JRPP No. Item 1 (2009SYE011)

DA No.	8.2009.298.1 -
Proposed Development	507 Military Road, Mosman - Demolition of the existing structures on the site and erection of a mixed use commercial/retail and residential development with part two, part three levels of basement for car parking
Applicant:	Roluke Pty. Ltd
Report By:	Stan Fitzroy-Mendis

EXECUTIVE SUMMARY

Figure 1: An elevation of the proposal fronting Cowles Road. Note the relationship with the existing residential flat building to the rear.

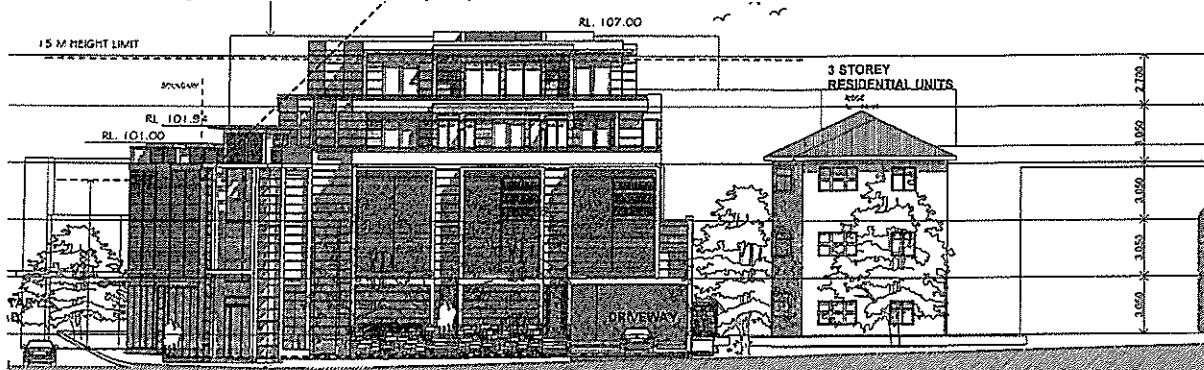
As noted above in the both the SEPP 1 assessment of FSR, and the SEPP 65 assessment, the proposal exceeds the FSR for the site by 35% and is not compatible or complimentary to the existing streetscape. The proposal also does not comply with the height, building height plane, and streetwall requirements (Section 5.3.1 below).

The proposed commercial/retail building has a two storey with mezzanine level facing Military Road. The desired streetwall height is defined in the MBCDCP in the Spit Junction precinct as two storeys. The streetwall of development to the east and to the north-west is predominantly two storeys. The proposal seeks a streetwall to Military Road that is two storeys with mezzanine level. The proposal would have an adverse visual impact on the Military Road streetscape and will not provide a cohesive streetscape. The proposal will dominate surrounding development, including the residential flat building to the south of the site. With regard to surrounding development, the proposed height is unsatisfactory.

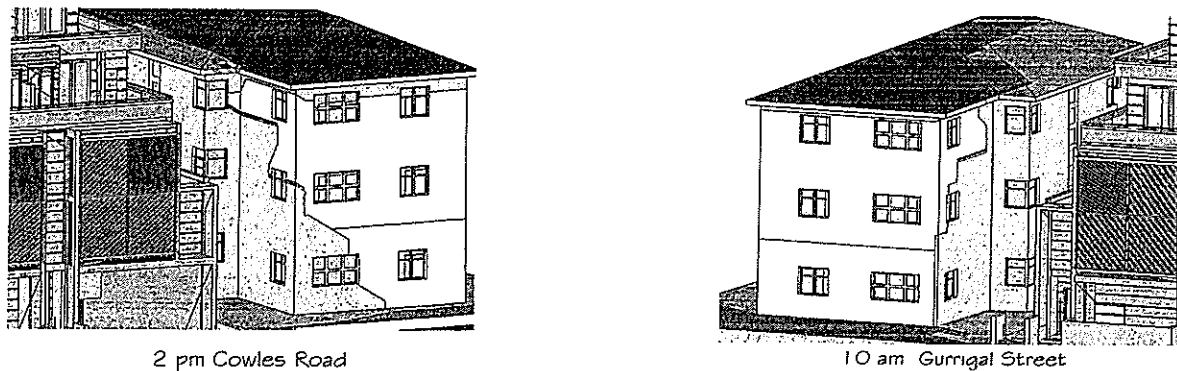
- The top level living area on Gurrigal side of 87A Cowles Road would have its north facing windows in shade from 11am onwards. The lower units will have overshadowing to its living room windows at this time; and
- The top unit living areas on the Cowles Road side of 87A Cowles Road would have their north facing windows in shade from 1-2pm. The lower units would have overshadowing to its living room windows at this time.

The north facing living room windows to all but the uppermost level will be overshadowed at times when it would be expected there would be solar access. This shadowing impact is largely due to the height, bulk, orientation, and setback of the proposal. The proposal does not meet reasonable shadow impacts in this context.

MILITARY ROAD ELEVATION
SCALE 1:300

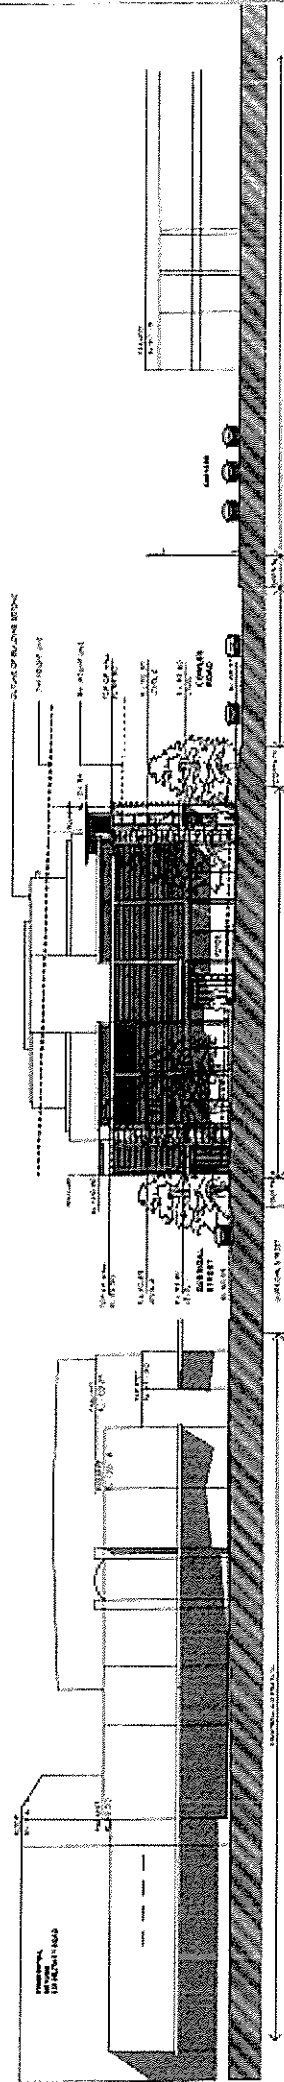
- Military Road Frontage - The applicant's architectural Plans DA 10 and DA 11 dated 7/9/09 illustrate a building height plane from Military Road. This plane has been taken from a point above the wall height of the second floor, at the point at the top of the wall height of the mezzanine. Contrary to the DCP approach, this in turn would show the proposal as not complying with the building height plane requirement to Military Road.
